PLANNING AND ZONING BOARD AGENDA

Meeting Name: Planning & Zoning Board
Meeting Date: September 21, 2026
Prepared By: Stephen Mayer
Item Title: Appearance Review – 401 Olympus Drive

Meeting Name: Planning & Zoning Board
Meeting Date: August 3, 2026
Prepared By: Stephen Mayer
Item Title: Appearance Review – 401 Olympus Drive

Property Address: 401 Olympus Drive, Juno Beach, FL 33408
Applicant / Owner: 401 Olympus Dr, LLC
Engineer of Record: Specialty Engineering Consultants, Inc., Boynton Beach, FL
Plan Date: April 9, 2026
Meeting Date: September 21, 2026

1 SITE PLAN
1/8" = 1'-0"

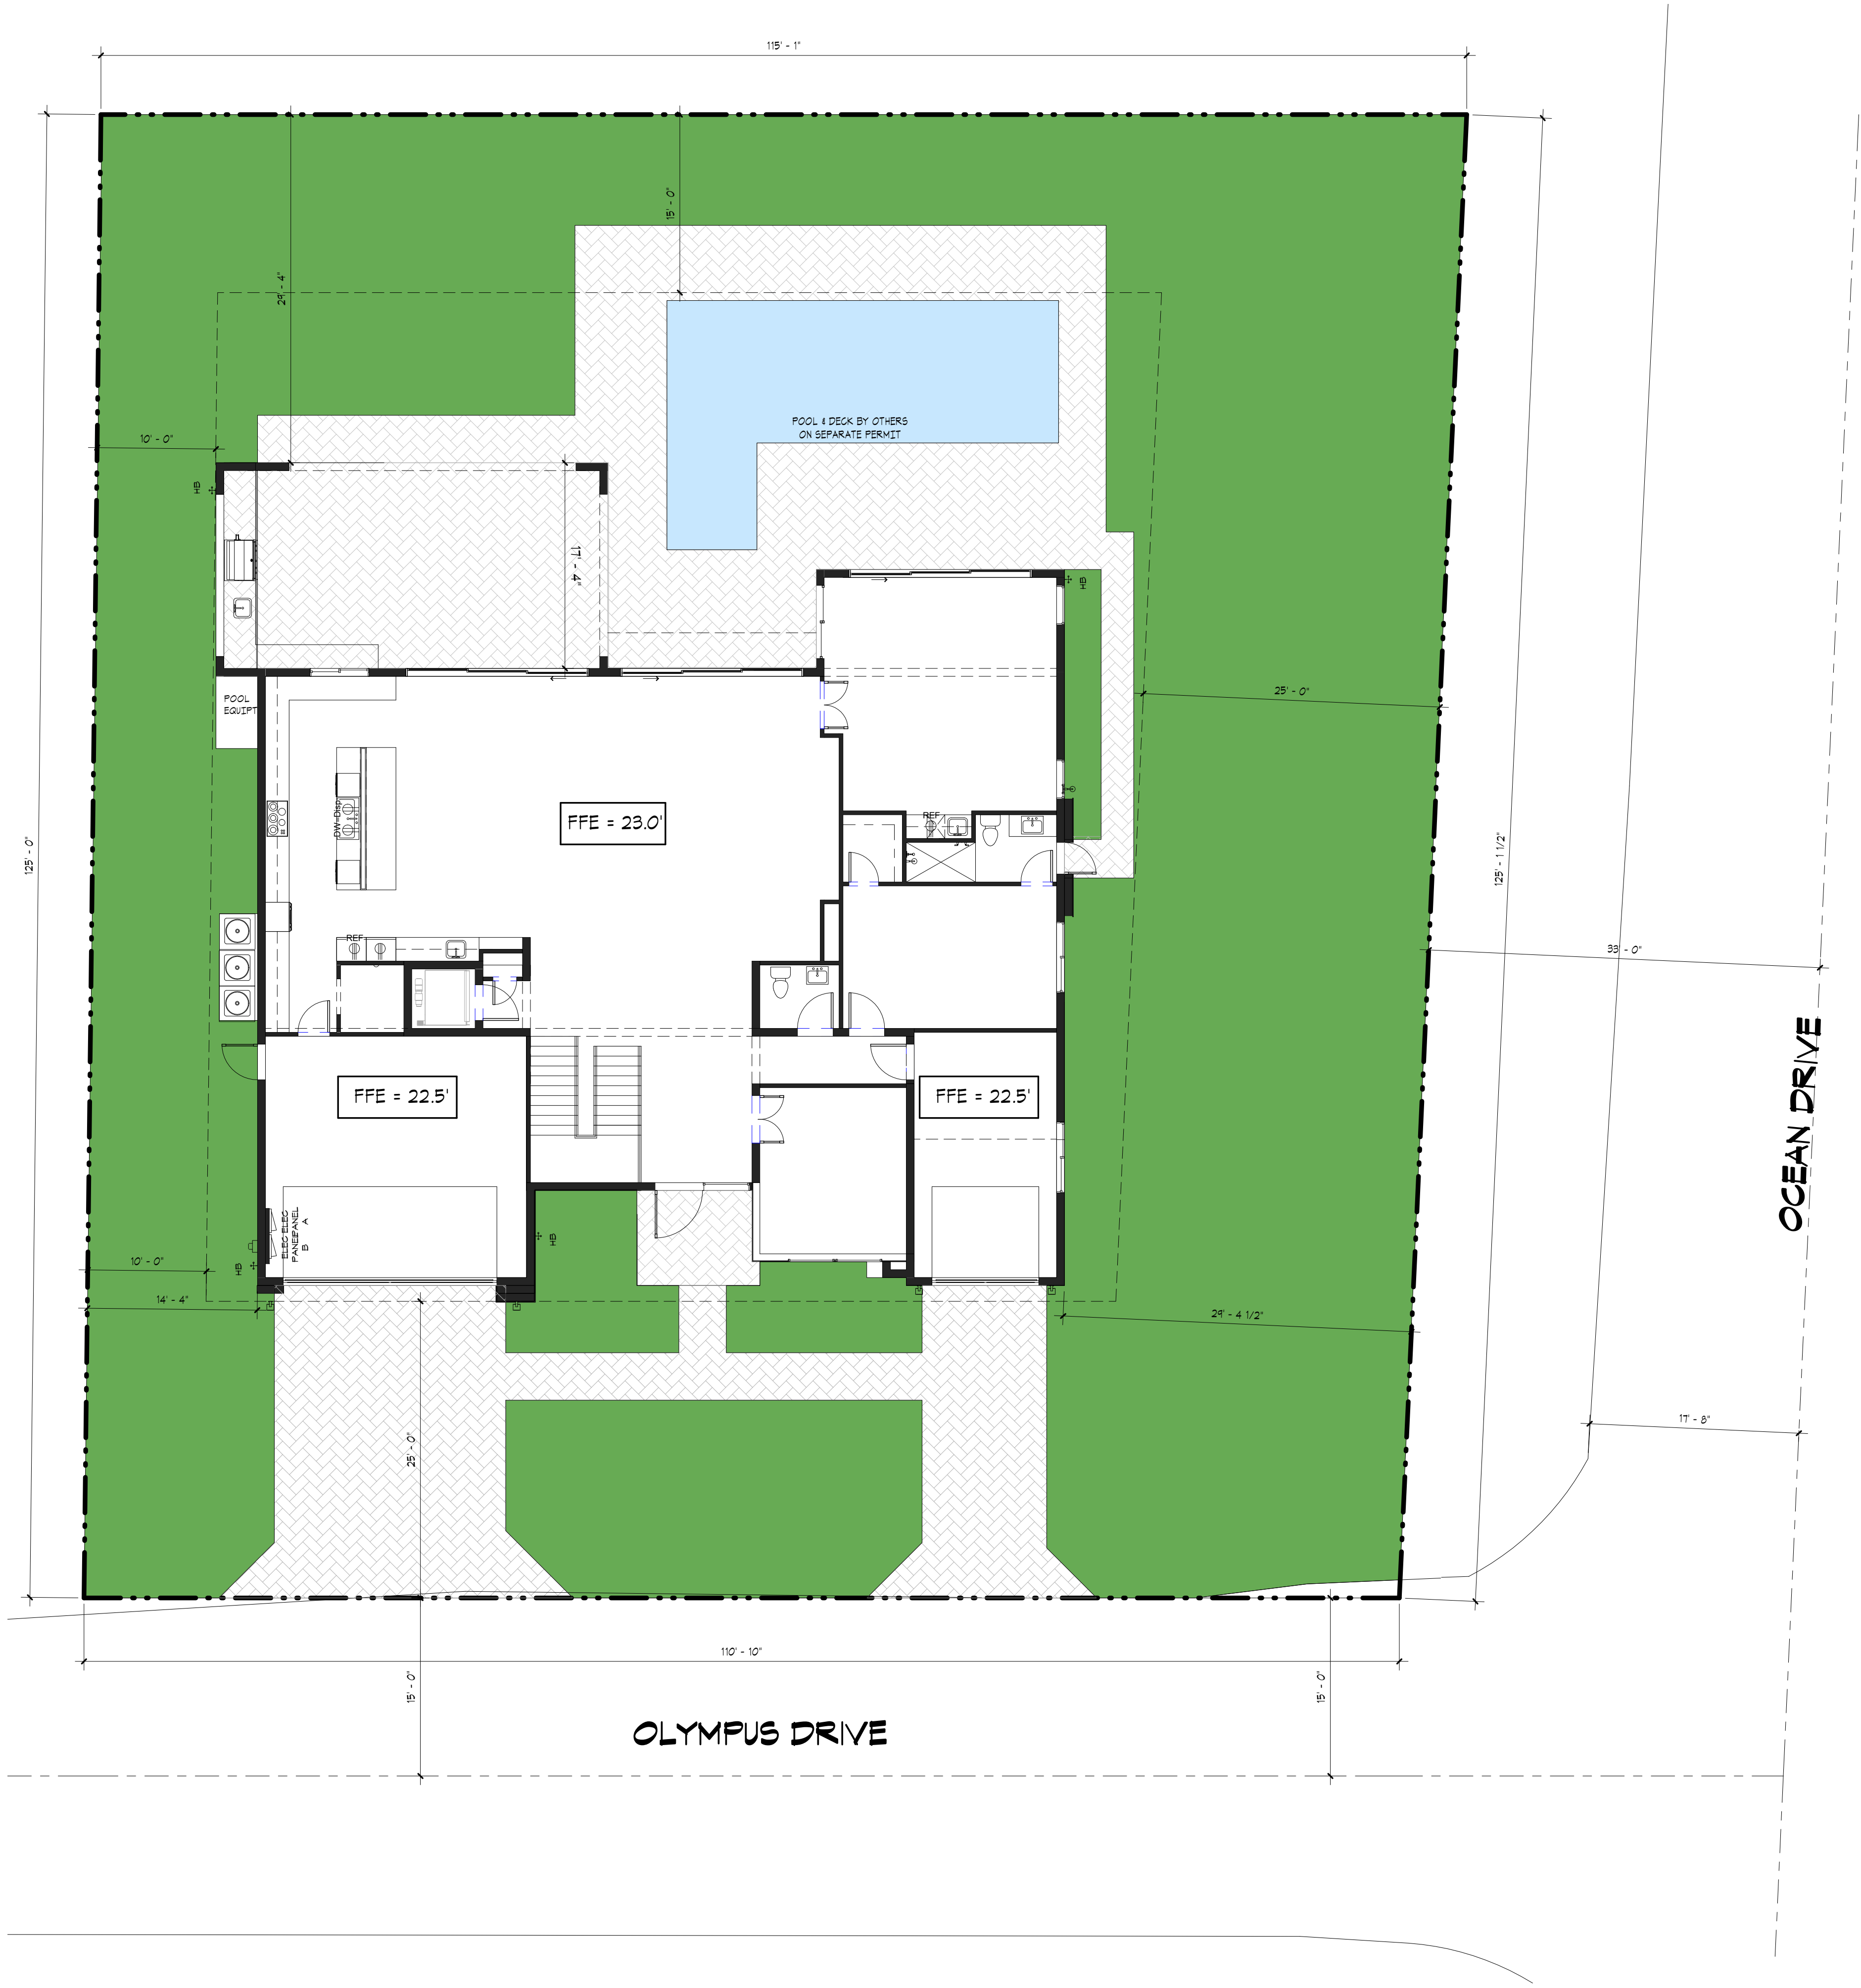
Note: the August 3, 2026 staff report's orientation narrative describes the Ocean Drive setback as "25 feet, which is the minimum setback," while the sealed site plan (Sheet SP-1) shows 29'-4" provided at that line. This narrative uses the site plan's sealed figure; the applicant welcomes the opportunity to confirm the correct as-built dimension with staff in advance of the hearing.

Front Corner / Ocean Drive side and Olympus rendered elevation

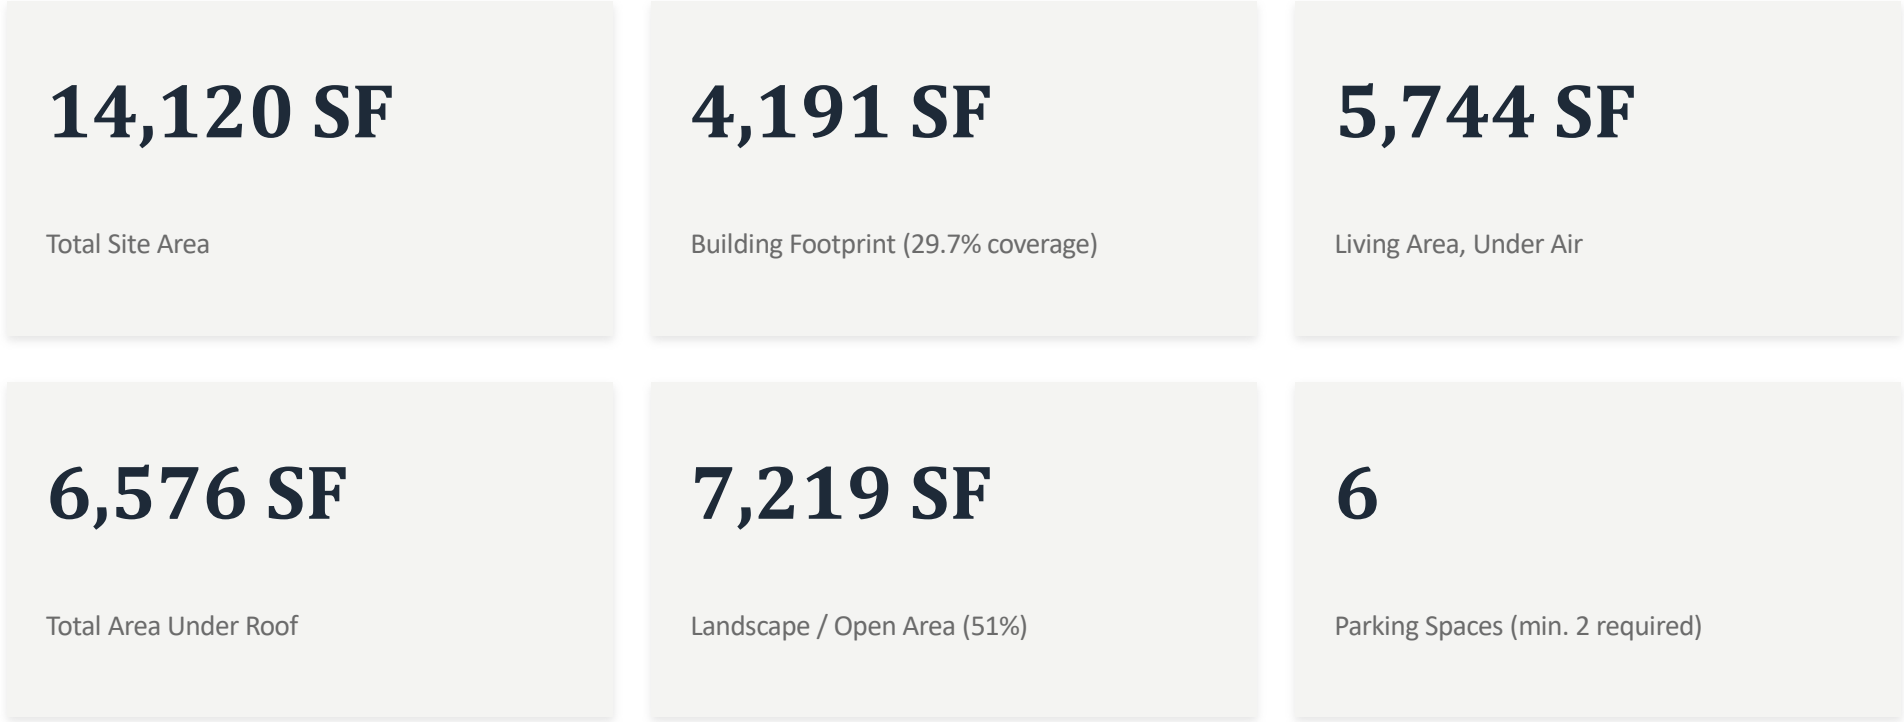
- Provide a rendering of the façade facing Ocean Drive;
- Modify the architecture to be more in line with mid-century modern style; and
- Reduce the size or mass of the house.

2. Added bump out and massing details. Through architectural reinforcement of materials and did not increase the square footage. The east second story and center of the Ocean Drive façade now include a protrusion that creates visual interest and a more significant separation of material changes. This was a request of the Town to provide the appearance of function over form contrast of the materials.

7. Added a window at the southeast corner of the second floor, to reduce the blank wall area overlooking Ocean Drive.
8. Extended window heights at the front center of the home. Additional glazed areas and greater sense of openness, opportunities for sight lines and greater relation to nature were areas that staff requested to be a guiding principle of the Mid-Century Modern Style.

It is staff's professional judgement that the proposed architecture does include key features of Mid-Century Modern architecture. For instance: clear sight lines that create a bridge between the interior space and the outdoors are now evident; innovative use of windows at the corners or full ceiling to floor; simple color palette or minimal use of light vernacular materials; creation of negative space; reduction of mass where materials change; and, sleek geometric lines with emphasis on horizontal planes. The façade facing Ocean Drive has been improved and does carry over the elements of Mid-Century Modern. The recommended flat roof line carries slight variations, especially from the perspective of Ocean Drive.

Landscape Plan

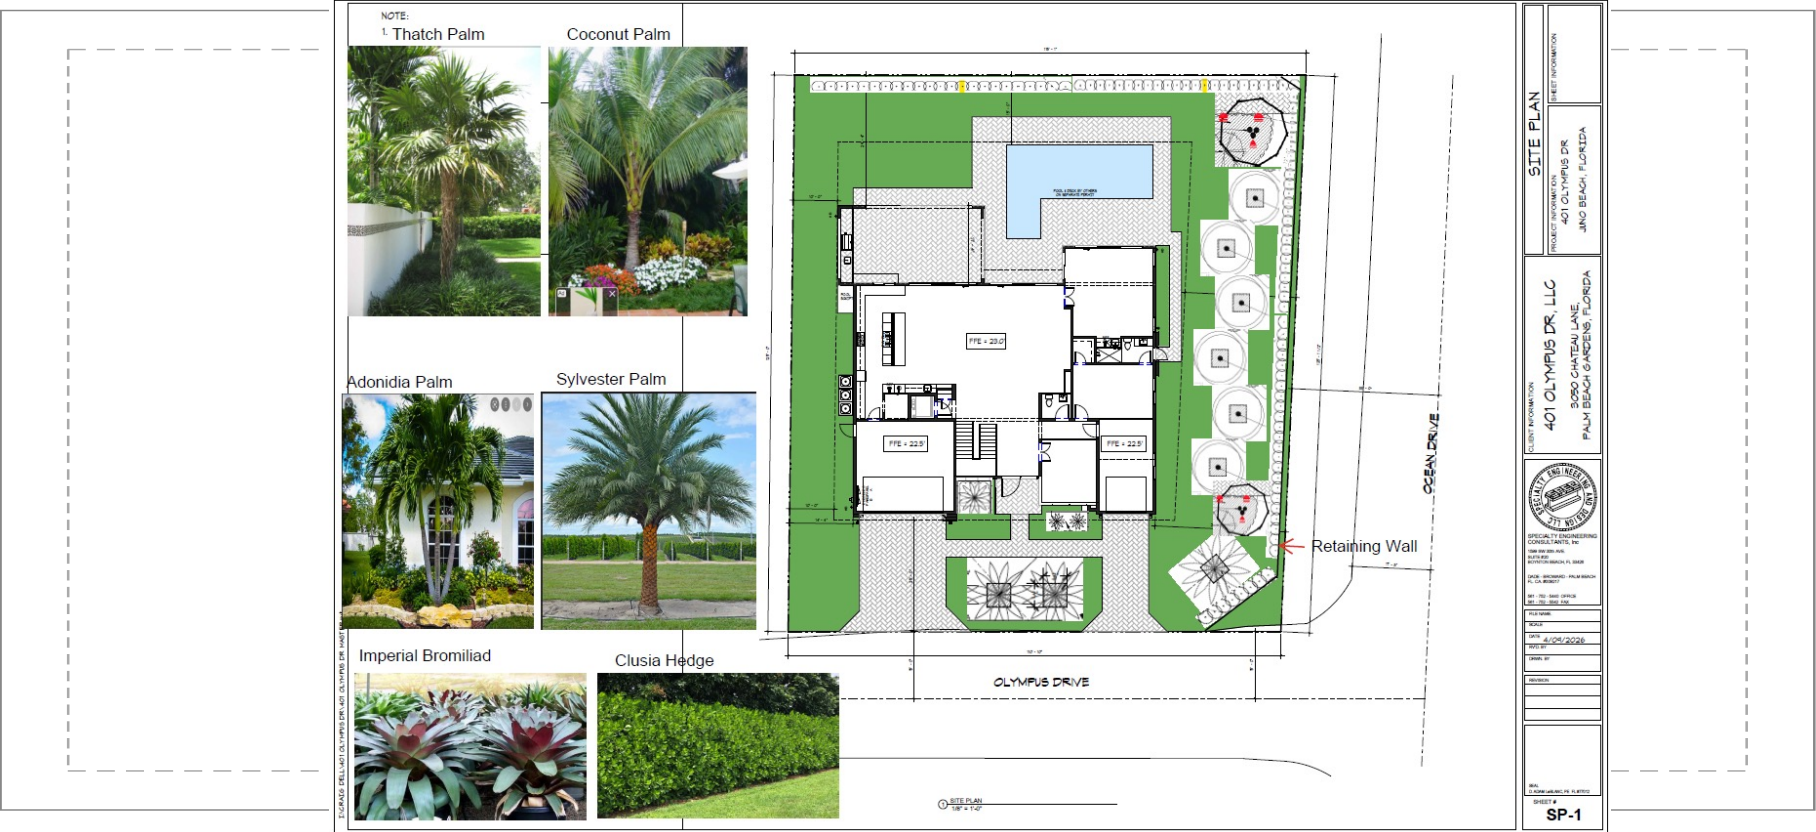
- Provide the proposed materials and colors, stated on the elevations;
- Provide the proposed landscaping, on renderings and on the plan;

Staff's response: The application does not indicate any landscape installation to be reviewed under the Appearance Section of the code.

Staff's response: The application indicates landscape installation in the rendering and justification statements. Please see the renderings below, and the landscape plans in the applicant's plans. The applicant intends to use a continuous hedge screening along the east facing wall to Ocean Drive, as well as a line of palms to reduce the visual impact of the home. Staff notes that the exterior wall does currently have a continuous hedge, although it is not shown on the rendering. It will be a requirement to replace any missing hedge material along the exterior side of the wall. The front façade and the southeast corner includes large ornamental planting beds that accentuate the front façade.

STAIR / ELEVATOR TOWER ROOF PLAN

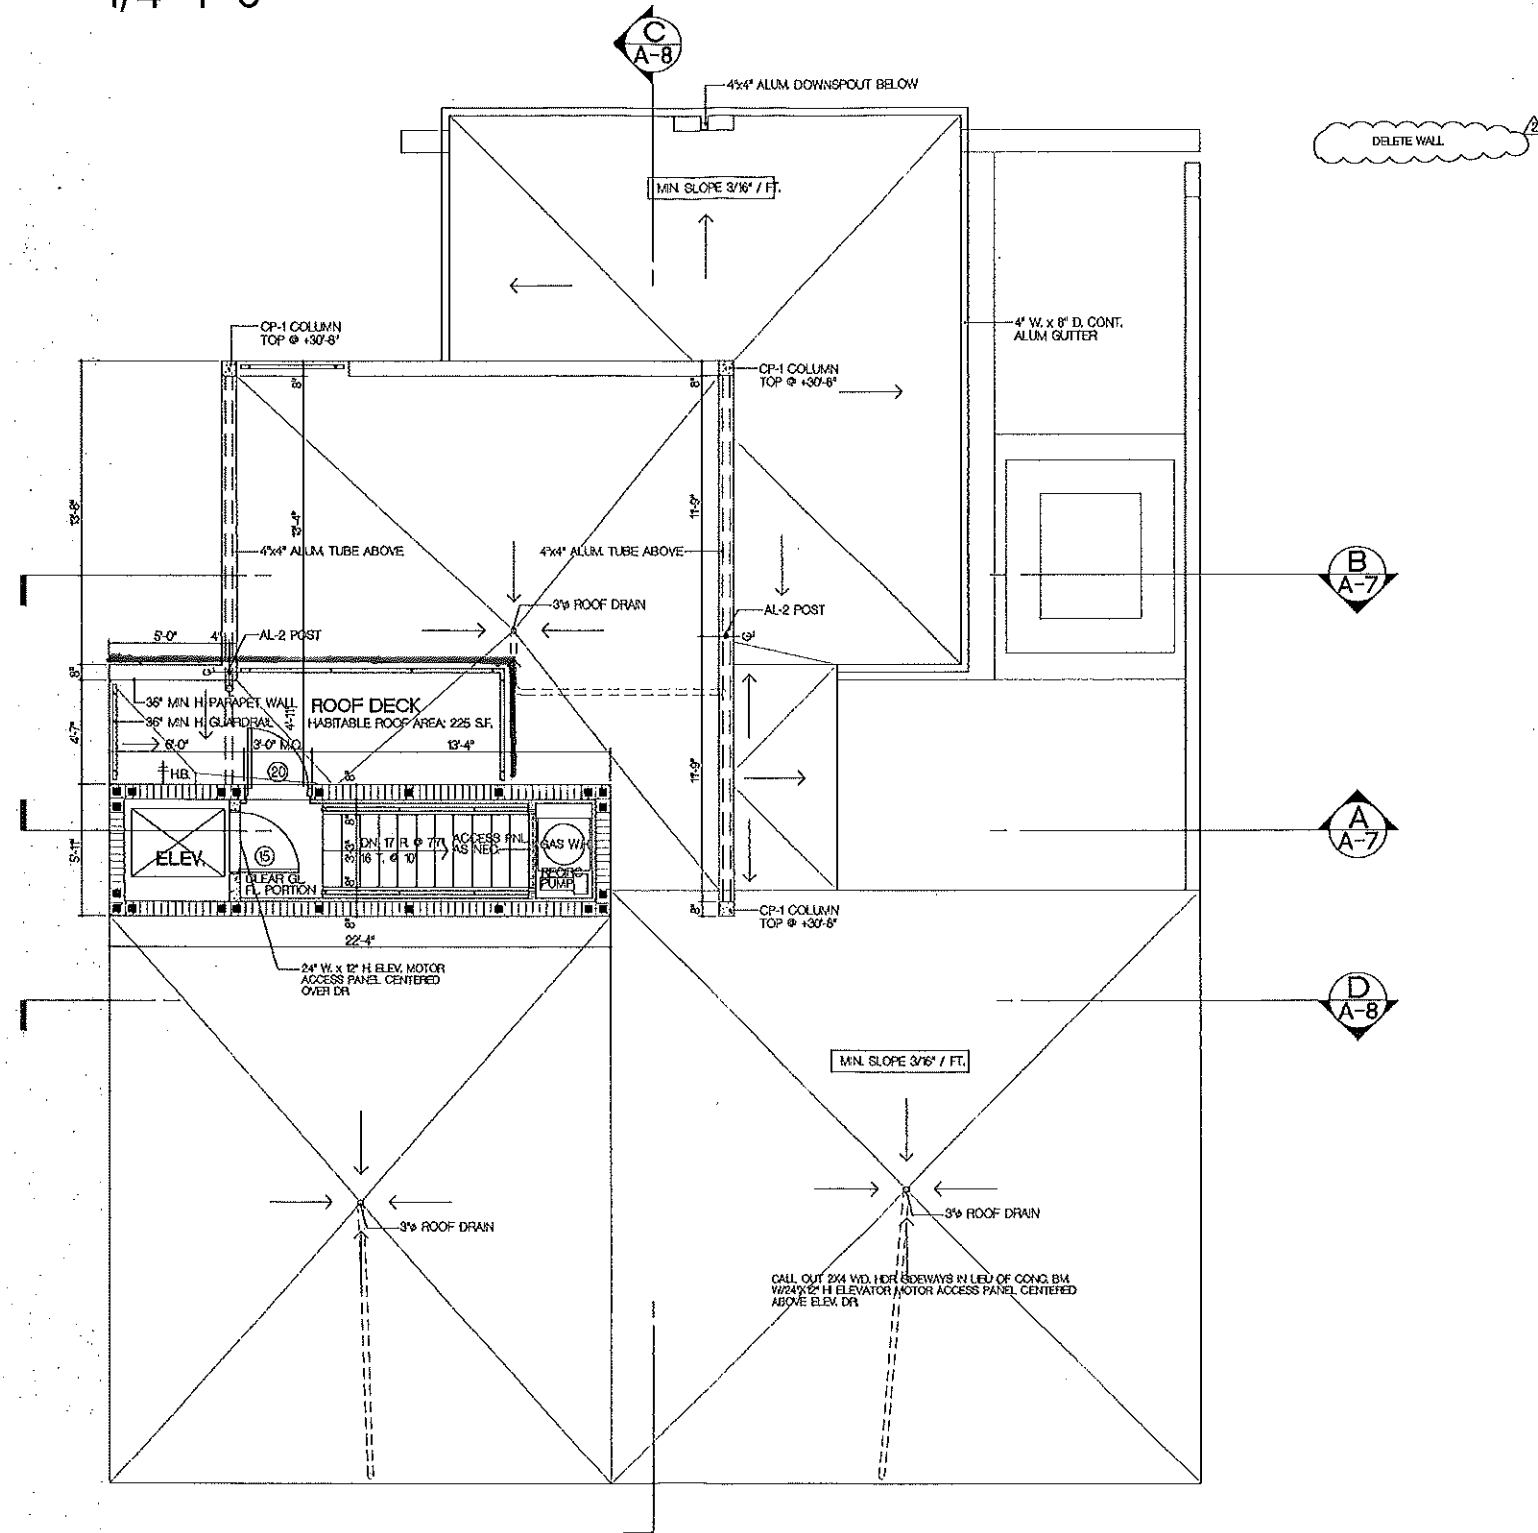
The applicant is seeking a variance from the Town's Zoning Code Section 34-268 – maximum Tower Area for residential properties to allow a gate to be installed instead of a fixed fence or wall to secure the tower area from the rest of a flat roof. According to Section 34-268, the maximum "Tower Area" is 225 square feet for the RS-2 Zoning District. Section 34-4 defines the term "Tower Area" as "an open air or enclosed structural feature which is an integral part of the principal structure, and whose floor area, from outside wall to outside wall, is limited in size. Such structural feature is intended to provide additional scenic view opportunities."

The Town finds that the definition is clear and has been consistently applied. Pursuant to the definition of a "Tower" under Town Code Section 34-4 and the maximum footprint limits under Section 34-268, a tower feature is treated as a single, unified structural feature whose floor area is strictly limited in size. Where a tower feature incorporates a gate in lieu of a permanent enclosing fence or railing, the accessible area outside the gate must be included in the total floor area calculation. Because the inclusion of a gate provides direct access to and functional use of the adjacent exterior space, that area forms part of the unified structural feature and must be counted against the maximum allowable area limit (e.g., the 225 sq. ft. maximum).

Staff recommends that an additional 30-day extension be authorized in order for Ms. Laukien to take the necessary steps to achieve compliance with the issues related to the roof-top tower feature that exceeds the maximum permitted area of 225 sq. ft.
